Frederick Road Bike Path, Mandatory Referral, MR2015025: Preliminary/Final Water Quality Plan

**4B. Frederick Road Bike Path: MR 2015025
Preliminary/Final Water Quality Plan**

Figure 2. Shared Use Path in area of proposed stream crossing

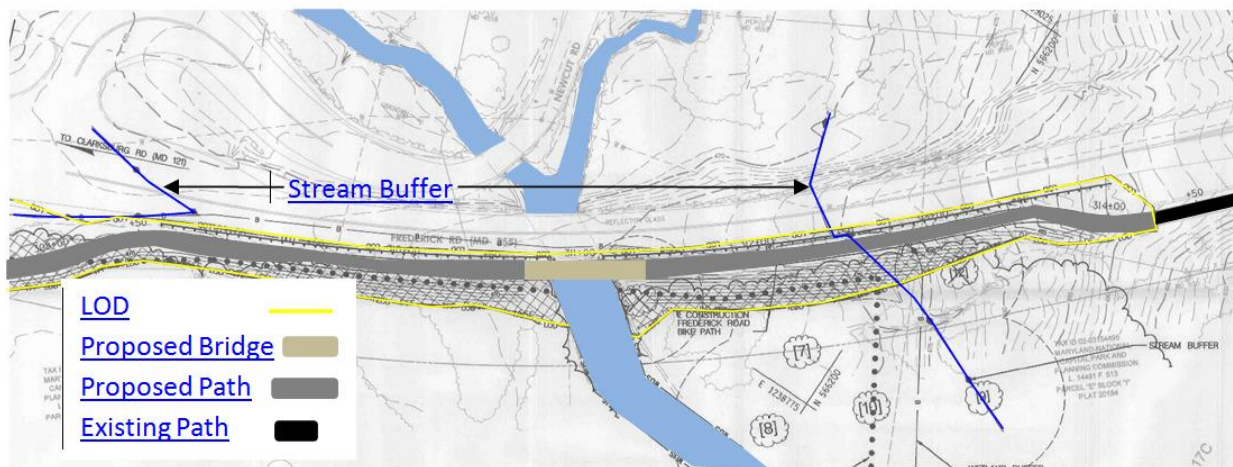
The shared use path will impact Little Seneca Creek and its associated environmental buffer as shown on Sheet 10 of the approved Forest Conservation Plan Exemption and Tree Save Plan 42015156E (Figure 2). The path is narrowed down to eight-feet wide at the bridged stream crossing to decrease impacts to the stream and forest loss. There will be approximately 15,285 square feet of disturbance within the environmental buffer which results in 7,975 square feet of forest loss. The impact to the stream and environmental buffer are necessary and unavoidable if this master plan path connection is to be achieved. The impacts have been minimized to the greatest extent possible while maintaining the accepted MDSHA design standards for constructing this regional shared use path.

Figure 2. Shared Use Path in area of proposed stream crossing

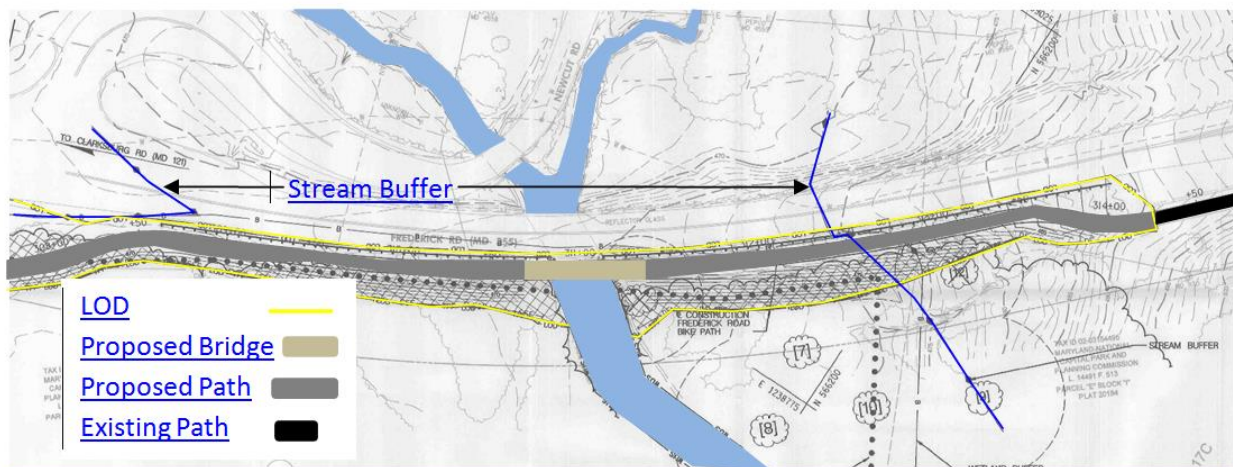
The shared use path will impact Little Seneca Creek and its associated environmental buffer as shown on Sheet 10 of the approved Forest Conservation Plan Exemption and Tree Save Plan 42015156E (Figure 2). The path is narrowed down to eight-feet wide at the bridged stream crossing to decrease impacts to the stream and forest loss. There will be approximately 15,285 square feet of disturbance within the environmental buffer which results in 7,975 square feet of forest loss. The impact to the stream and environmental buffer are necessary and unavoidable if this master plan path connection is to be achieved. The impacts have been minimized to the greatest extent possible while maintaining the accepted MDSHA design standards for constructing this regional shared use path.
